3 RESPONSES TO COMMENTS ON THE DRAFT EIR

This chapter contains comment letters received during the public review period for the Draft EIR, which concluded on February 19, 2019, including transcribed comments received during the February 14, 2019, public hearing. In conformance with Section 15088(a) of the State CEQA Guidelines, written responses were prepared addressing comments on environmental issues received from reviewers of the Draft EIR.

Exhibit 3-2

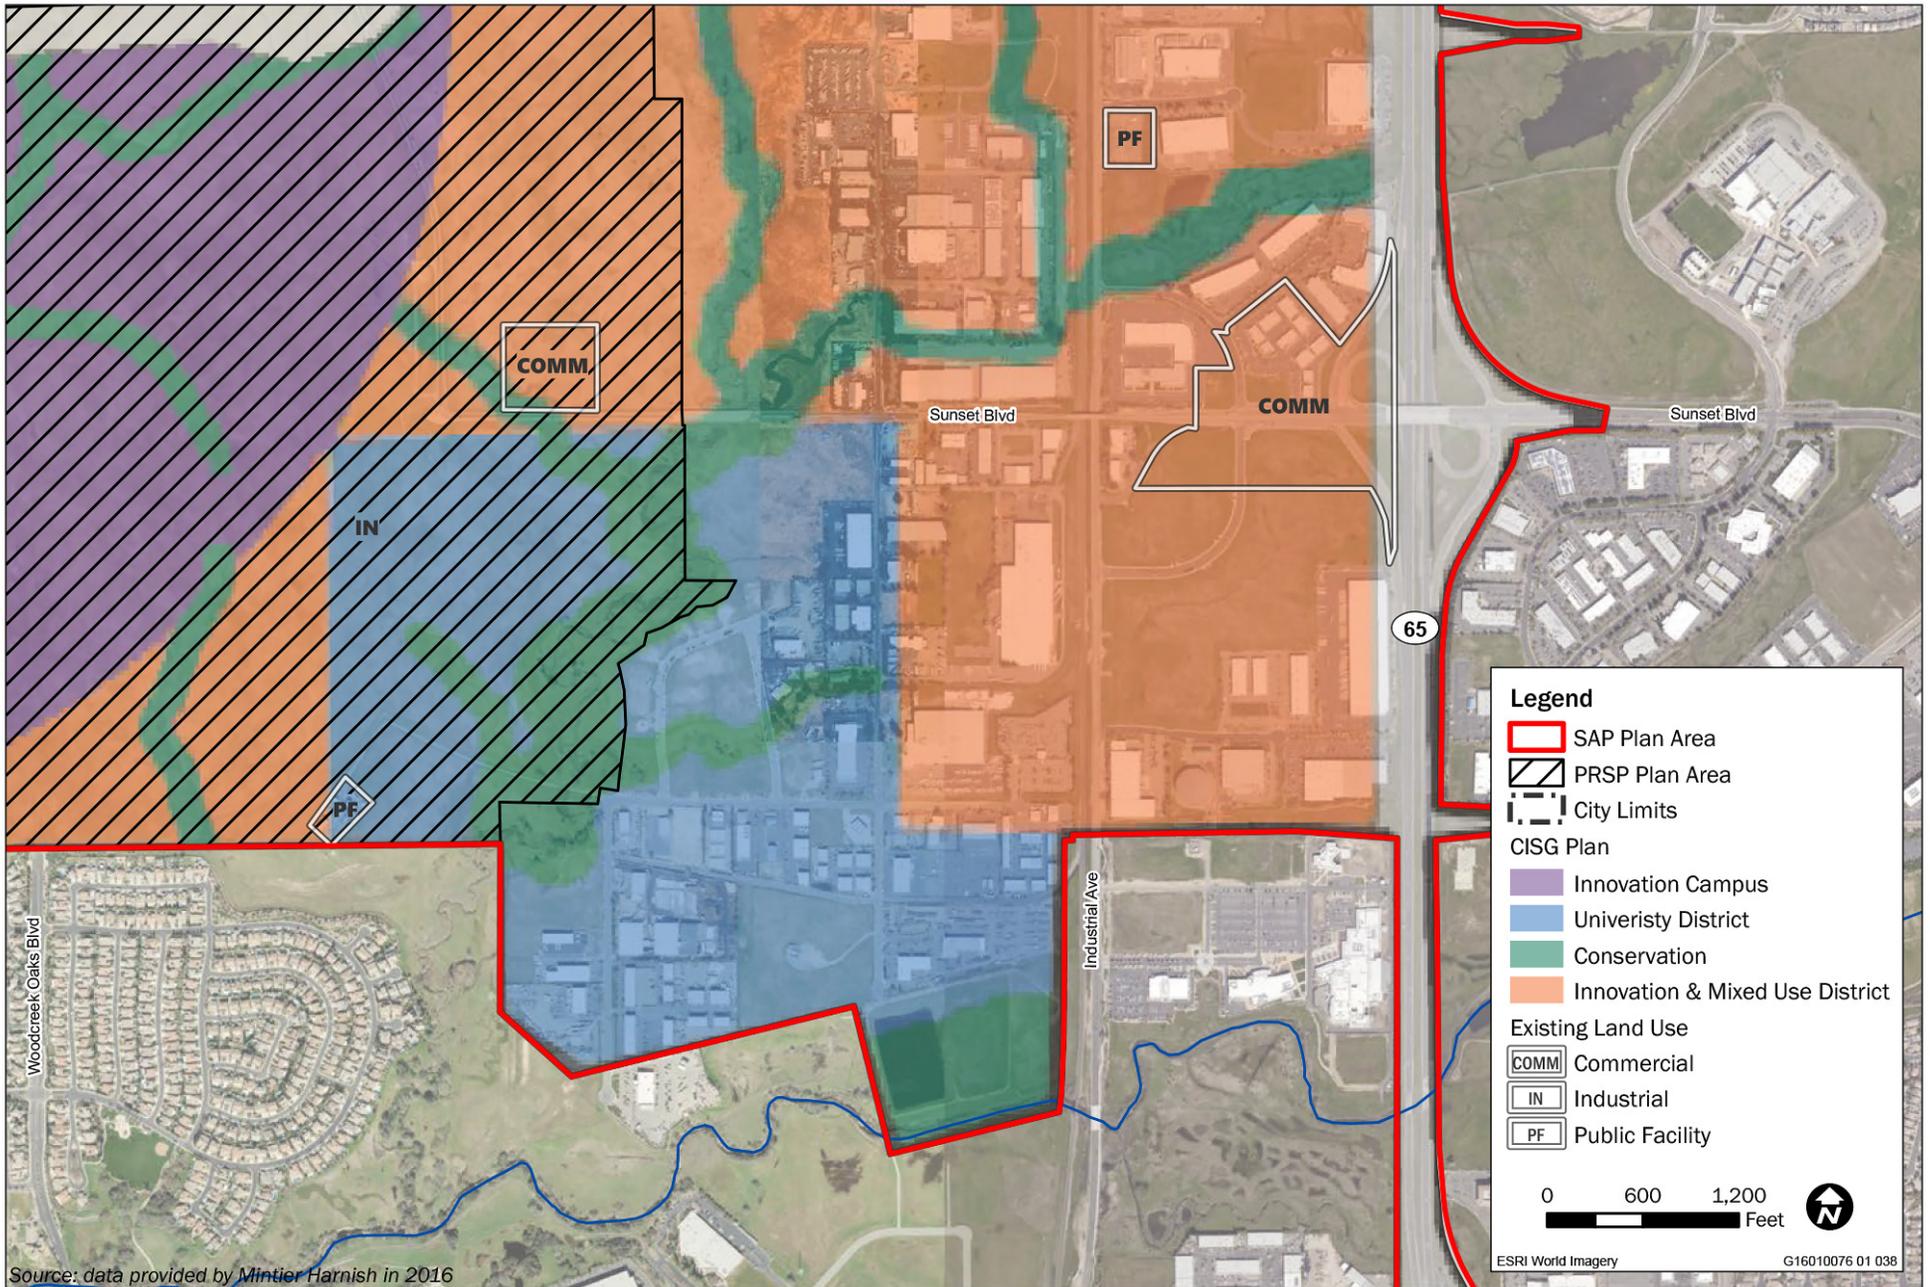
The second feasibility issue related to the CISGP's University District location is that it encompasses a substantial area of land that is already developed. See Exhibit 3-2. In order to develop these properties with university uses, the existing structures and infrastructure would need to be either demolished or repurposed. The CISGP promotes adaptive reuse of these structures and infrastructure as a positive aspect of the plan, indicating that adaptive reuse will help the university develop with less infrastructure and utility expansion cost. When feasible, adaptive reuse of structures is usually environmentally superior to demolition and new construction. Adaptive reuse is often a viable strategy when one, or possibly a few structures are involved and is most commonly used to avoid demolishing historic or otherwise important/valuable structures. However, the large, primarily single-story existing warehouse-style buildings that dominate the CISGP's University District are not historically significant and are incongruous with the types of structures necessary for a modern university campus. Also, the current layout of the existing structures, which are separated from each other by roadways, vacant land, and parking lots, would present major constraints for designing a cohesive university campus that is internally and externally well-integrated and that would allow convenient pedestrian access between buildings. Finally, the infrastructure (i.e., roads, power/gas lines, and water/wastewater lines) currently supporting the existing industrial uses would not be sufficiently sized to support an entire university use, as suggested by the CISGP.

Exhibit 3-3

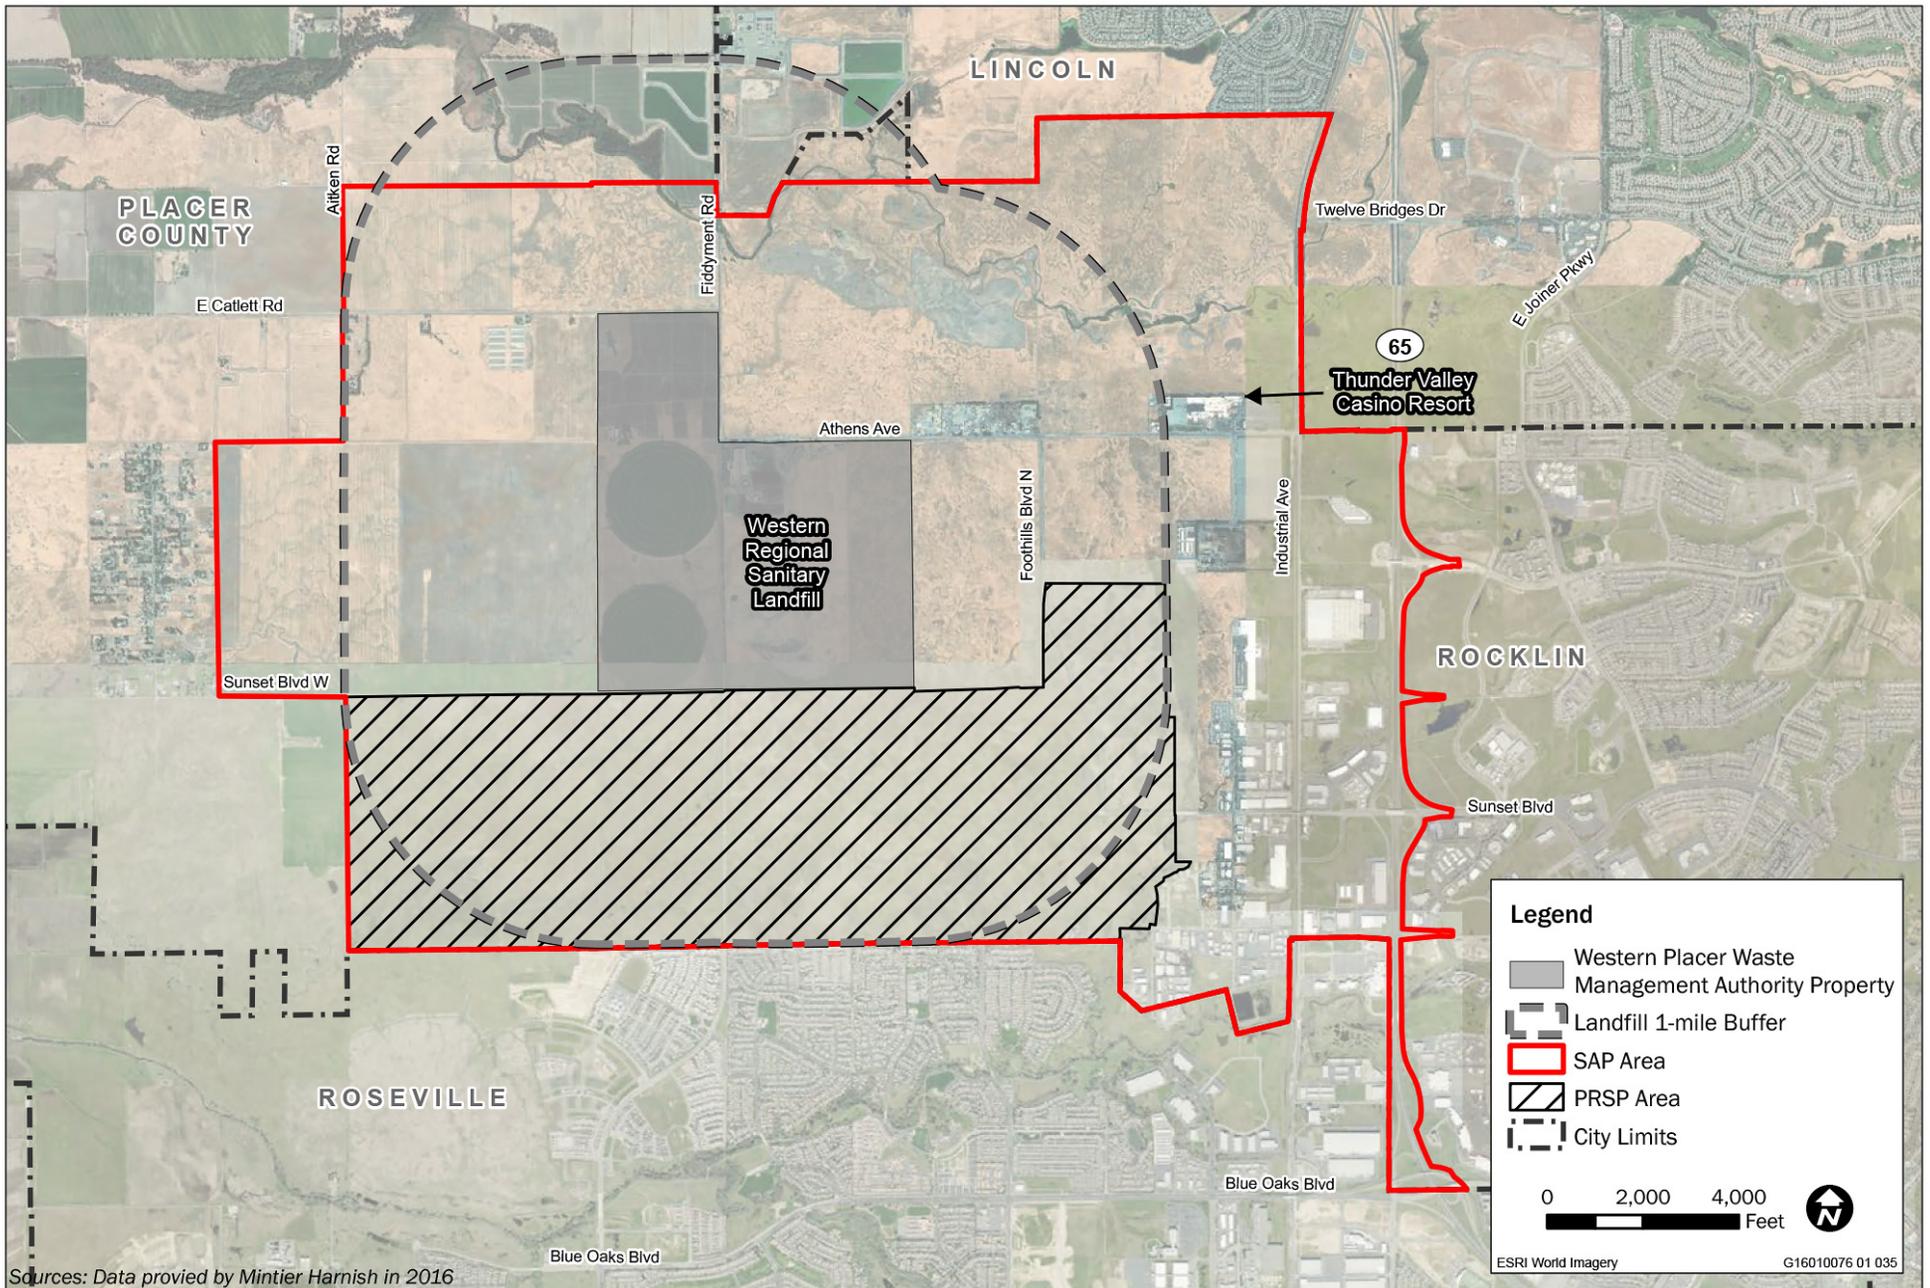
It is important to note that the primary reason offered by the CISGP for siting the University District in the selected location was to move it outside the existing 1-mile landfill buffer. This attempts to reduce the project's significant impacts related to odor and land use compatibility. The County understands the difficulty in identifying land outside the 1-mile buffer that could feasibly support development of sensitive land uses, including a university. During the alternatives development process, County staff and consultants examined undeveloped areas outside the 1-mile buffer that would be appropriate for sensitive land uses. Exhibit 3-3 shows the land outside the 1-mile buffer. Unfortunately, due to the size and central location of the Western Placer Waste Management Authority (WPWMA) property in the SAP area, land outside the 1-mile buffer is limited to the corners and edges of the SAP area. Much of the land in these areas is already developed with existing industrial uses. Developed areas were not considered feasible for the reasons described above. Existing natural features such as creeks, as well as large existing preserve areas, further restrict the availability of developable land outside the 1-mile buffer. Large, contiguous areas of vacant land, which would be necessary to allow development of well-planned and well-integrated housing to support the proposed commercial uses and meet project objectives related to provision of housing, were not available in these areas. Vacant land in these areas would restrict residential development to a patchwork of small subdivisions surrounded and disrupted by existing industrial uses. It is important to note that, although the CISGP suggests an adaptive reuse approach for existing structures in the University District (which, as discussed above, would be infeasible), it does not provide an approach for addressing the same issue for the large number of existing industrial structures in other CISGP zoning types, most notably the types that allow residential uses, including the Town Center, Office and R&D, and high-density industrial mixed-use subtypes. It is unclear how the large, single-story existing structures, which have been historically used for industrial uses, would be appropriate for re-use as residential structures. It is also unclear how the zoning types that permit residential uses would function cohesively given the pattern of existing structures (discussed above).

For these reasons, County staff found that an alternative to the project that meets most of the project objectives, while prohibiting sensitive uses within 1 mile of the WPWMA landfill property, was infeasible. The only alternative identified in the Draft EIR that maintains the 1-mile buffer is the No Project—1997 SIA Plan Alternative. The 1997 SIA Plan is consistent with the 1-mile buffer policy because the primary type of development allowed is industrial and other non-residential development types. However, as stated in the Draft EIR (page 6-28) implementation of the No-Project–1997 SIA Plan Alternative would not meet most of the primary project objectives for SAP and would not meet any of the primary objectives for the PRSP.

Exhibit 3-5

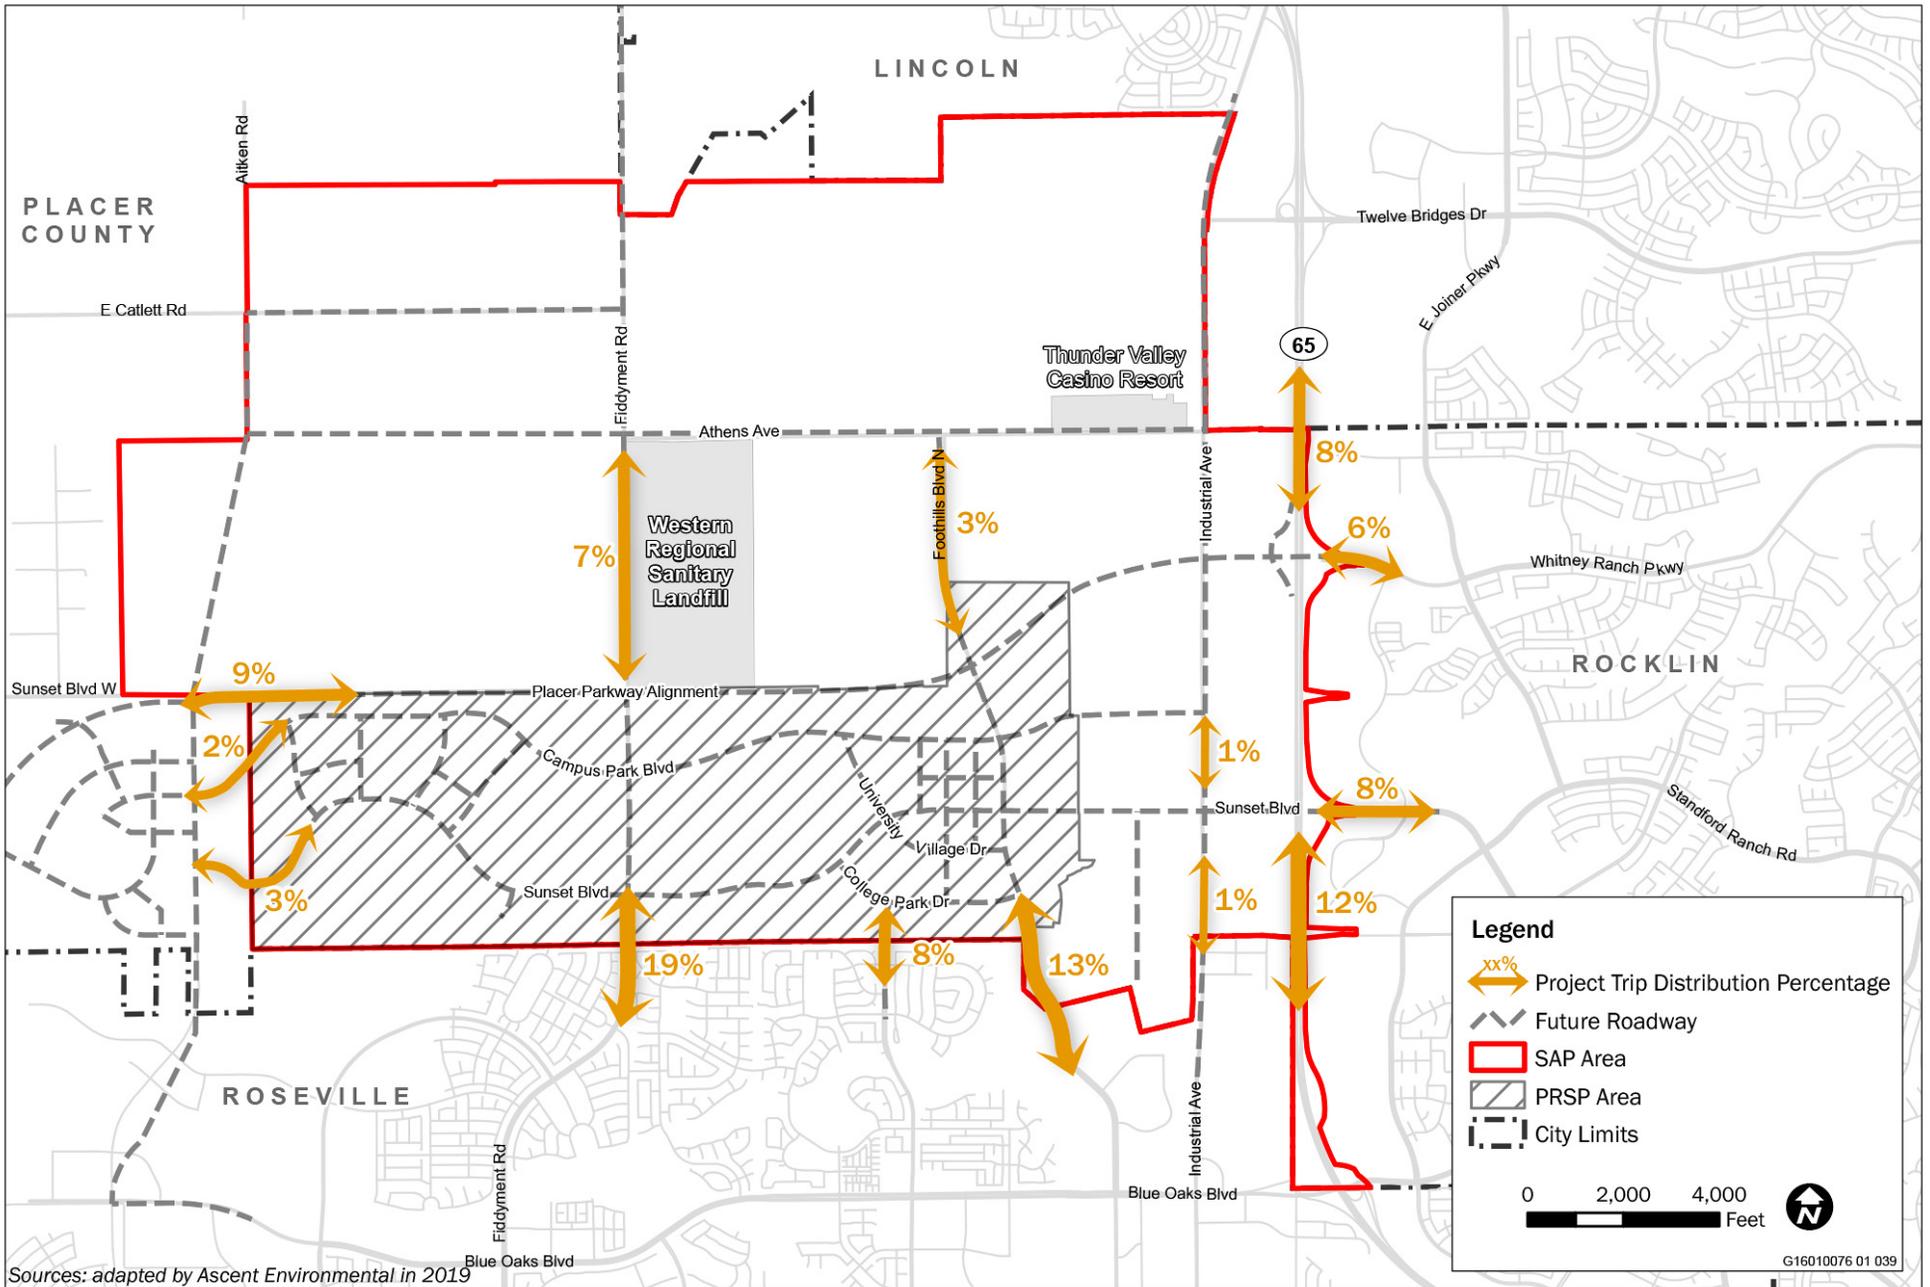
1-1 The comment requests a project-only trip generation table to identify the number of trips generated by the project. The comment raises issues with Draft EIR Exhibit 4.14-11, stating that the changes in average daily traffic (ADT) shown do not convey the effects of project trips on State Route 65 (SR 65). The comment also requests a trip distribution figure to show the travel patterns from trips generated by the project. Table 4.14-19 in the Draft EIR presents the project trip generation for the PRSP. As described on page 4.14-43 of the Draft EIR, Exhibit 4.14-11 reflects the project's effect on sub-regional travel patterns. This means the analysis accounts for a redistribution of existing trips that would occur with the proposed project. For example, nearby residents that currently travel to businesses and services further away may instead travel to businesses and services that are located in the PRSP area. As a result, some existing trips on SR 65 travel to destinations in the proposed project, resulting in a decrease in trips on some segments as existing traffic diverts off SR 65. Furthermore, the addition of project trips is partially offset by this redistribution of existing trips resulting in a lower net increase. As shown in this figure, the greatest change in traffic occurs on roadways that directly serve the PRSP area, which is expected with the addition of project uses. Intuitively, the project's effect on traffic dissipates further from the project.

In response to the comment, a trip distribution exhibit has been prepared (Exhibit 3-5).
